Contract #: 04-0120F4Cty: SF/ALA Rte: 80 PM: 13.2/13.9File #: 69.25B**QUALITY ASSURANCE -- NON-CONFORMANCE REPORT****Location:** Changxing Island, Shanghai, P.R. China**Report No:** NCR-000306**Prime Contractor:** American Bridge/Fluor Enterprises, a JV**Date:** 10-Jun-2009**Submitting Contractor:** Zhenhua Port Machinery Company, Ltd (ZPMC), Changxing Island**NCR #:** ZPMC-0280**Type of problem:**

Reference Description: Improper Welding/Cleaning, Weld OBW5A-004, 5AW/5BW Segment Splice**Description of Non-Conformance:**

Subject: NCR No. ZPMC-0280

WELD NUMBER: OBW5A-004

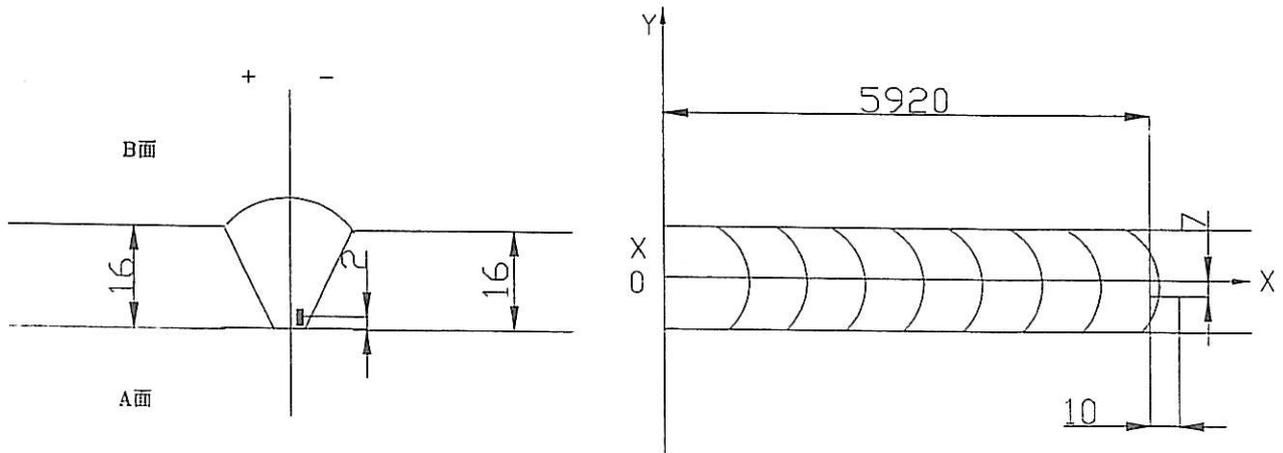
Description of welding discontinuity:

Rejected indication found by ultrasonic inspection is less than the maximum allowance aggregate length.

(UT探伤发现的缺陷总长度小于最大允许长度。) OBW5A-004

Caused:

1. Did not clear the weld pass completely in time.

Disposition :

1. Gouge or grind from nearer side from metal edge ($D \leq 0.65T$, "D" is depth of defects, "T" is thickness of metal) to remove all defects;
2. Follow repair WPS for joint preparation, preheat, and weld deposit;
3. Verify with VT no defects remain in the weld joint prior to welding;
4. Grind the repaired area flush with base metal or the adjacent weld;
5. Check the welds according to the working drawings;
